First prototype of the 1337 3310 tool
(c) Cristiano Griletti 2015
Released as Open Hardware under CC BY-SA 3.0 license
<http://creativecommons.org/licenses/by-sa/3.0/legalcode>

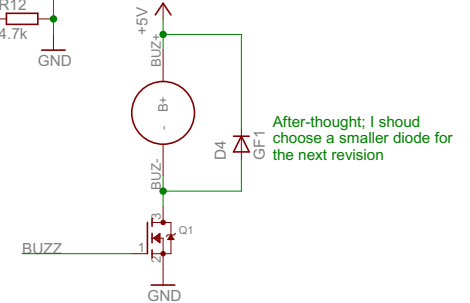
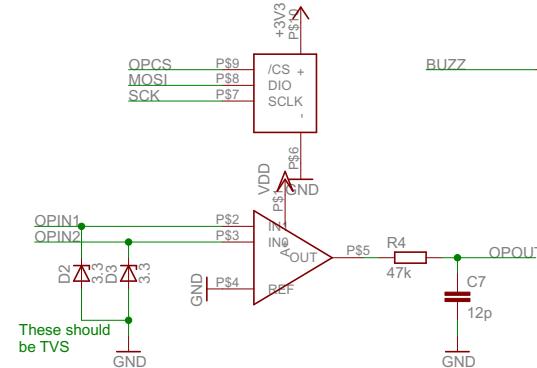
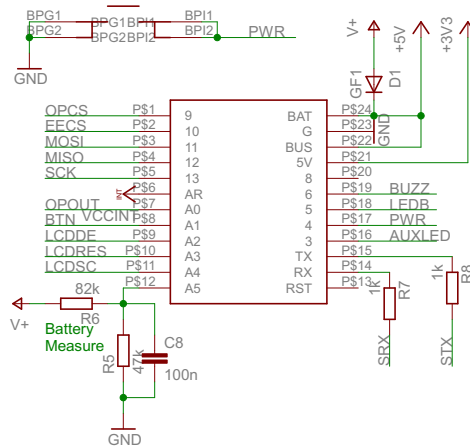
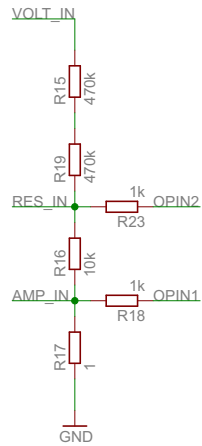
I should put a buffer on the Ref voltage...

After-thought; I should choose a smaller diode for the next revision
